SERVICE INSTRUCTIONS

No. 0574-241
ATA Code 71-00

SUBJECT: POWERPLANT - MODIFICATION OF CARBURETOR AIRBOX VALVE

Figure 1. Looking Down on Carburetor Airbox

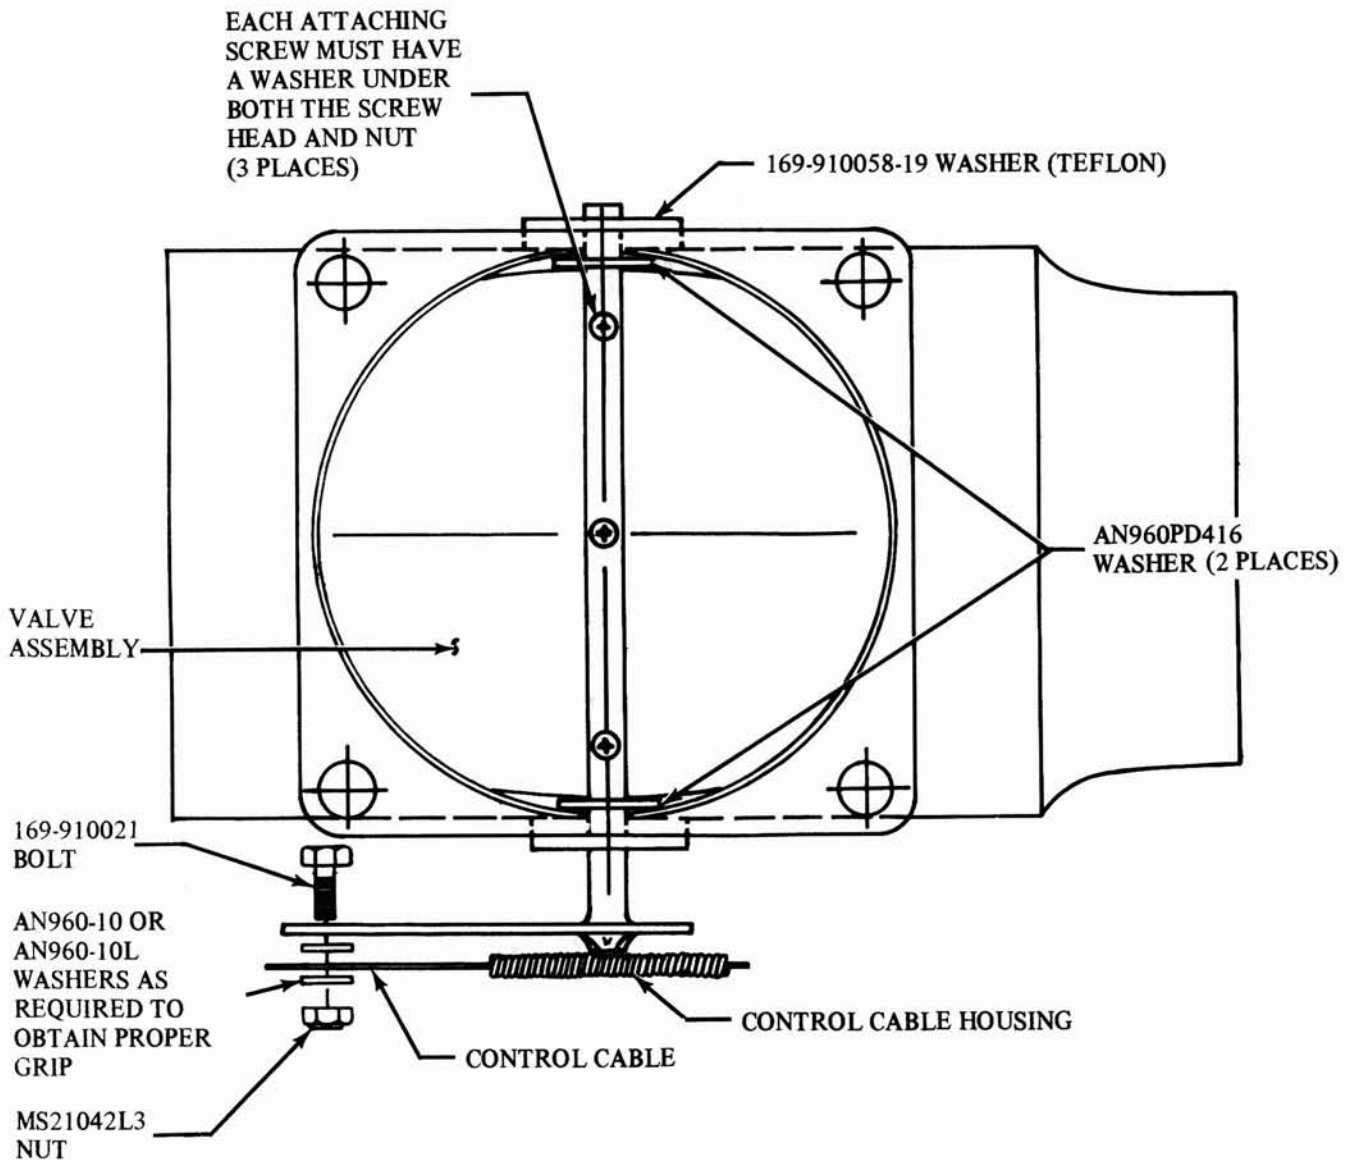
8. Install the new valve assembly and AN960PD416 washers as indicated in Figure 1.
9. Install the new screws, washers and nuts through the valve and shaft making certain to place a washer under both the screw head and the nut.

Figure 2. Looking from Left to Right in Engine Compartment

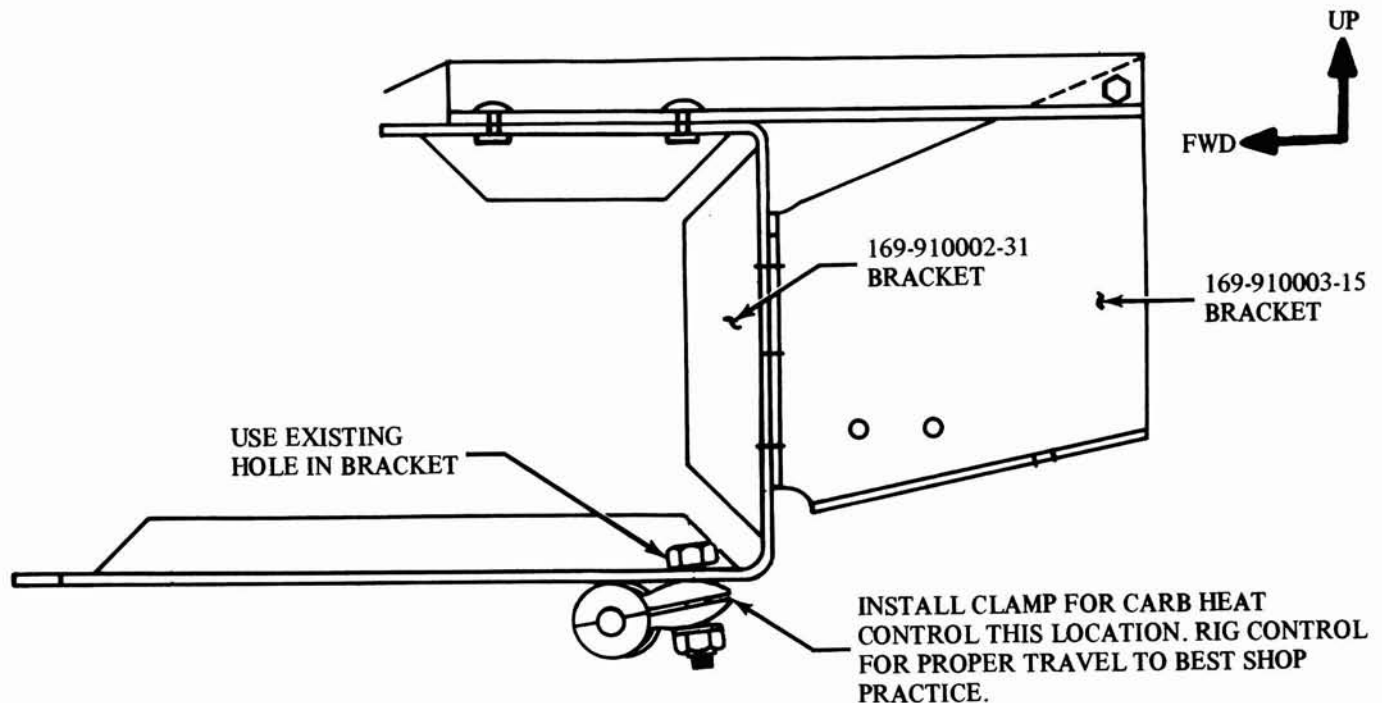
13. Remove the carburetor heat control housing clamp from the upper rear corner of the bracket and reinstall at the existing hole in the aft end of the bottom flange of the bracket as indicated in Figure 2.

On Model A23-19, 19A, M19A, B19 and Sport B19, serials MB-1 through MB-558 it is necessary to relocate the control cable clamp.
